LSPI SURVEILLANCE PANEL MINUTES

Date: 15 Nov 19

Seq IX Dealer Piston Batch Introduction

Sequence IX SP Call

Piston Measurements

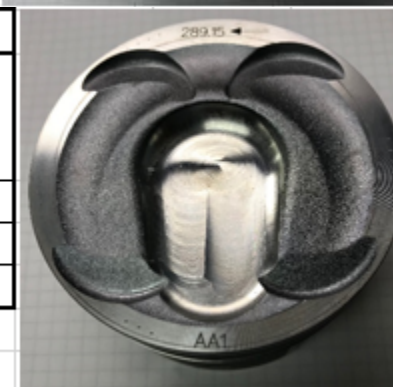
- Robert Stockwell wanted everyone to be aware that we will be approving these pistons designation AB1) on only two references.
 - Ron Romano advised the group that these dealer pistons are very similar to the BB pistons and he has no issue with using them. In fact, the AB1 pistons are closer to the BBs than the AA1s because the AB1s and BBS have a 2.5 mm oil drain holes while the AA1s have 3 mm holes.

To allow the use of dealer pistons AG9Z-6108-D for Sequence IX registered testing following a successful calibration (two reference runs). AA1 pistons will be consumed before switching to AB1 pistons. At least one of the calibration runs must use oil TMC 224. Effective 11/15/2019.

Processing Issues

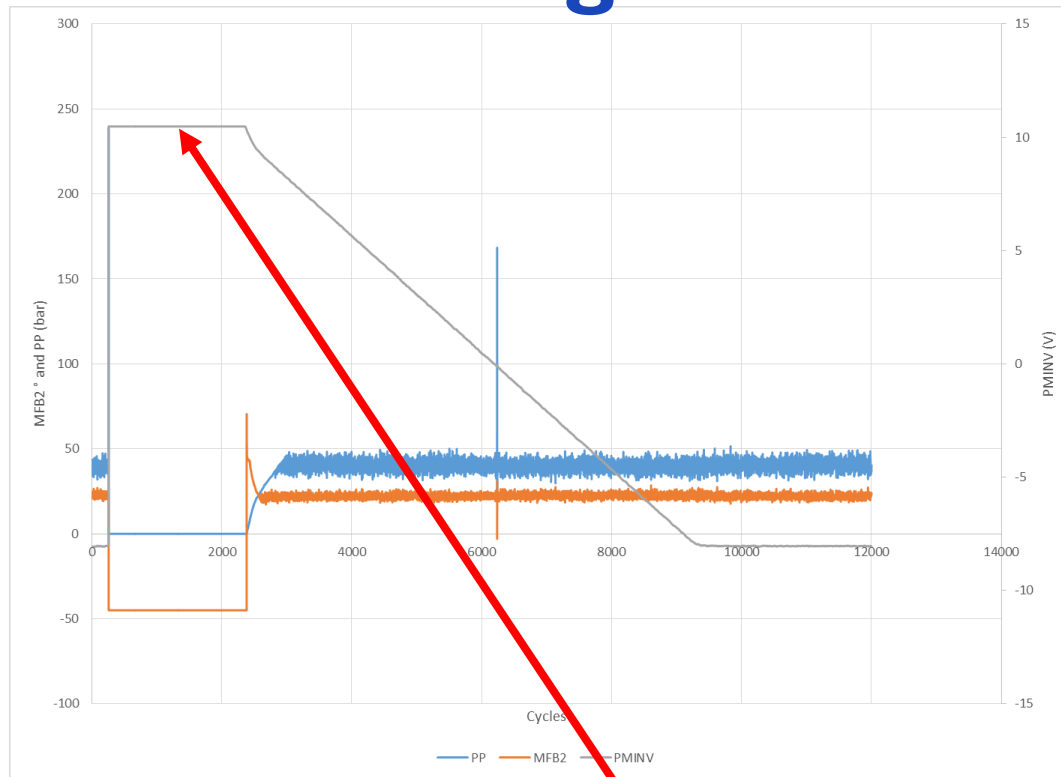
12.2.2.1. Remove all cycles with a *MFB2* < -30°. #1

12.2.2.3 After all invalid *MFB2* and *PP* cycles have been removed (see 12.2.2.1 and 12.2.2.2), remove all cycles with a pressure minimum voltage (*PMINV*) less than the mean of remaining *PMINV* - 0.5 V. For example, if the mean *PMINV* of the remaining engine cycles on cylinder 1 is -8.02 V, remove all cycles with *PMINV* < -8.52 V. #2

Processing Issue #1

Not counted because $MFB2 < -30$
Recommendation: Should the limit be > 30 ?

Processing Issue #2

Valid because $PMINV > -8.5$

Recommendation: Should the limit be $abs(PMINV - PMINV \text{ mean}) > 0.5$ is invalid?

- Motion 1: To change section I2.2.2. to “Remove all cycles with a $MFB2 > 30^\circ$ ” instead of the current “Remove all cycles with a $MFB2 < -30^\circ$.”
- Motion 2: To change I2.2.2.3 to ...“remove all cycles with a pressure minimum voltage (PMINV) different than the mean of remaining PMINV by more than 0.5V. For example, if the mean PMINV of the remaining engine cycles on cylinder I is -8.02 V, remove all cycles with $PMINV < -8.52\text{ V}$ or $PMINV > -7.52$.”
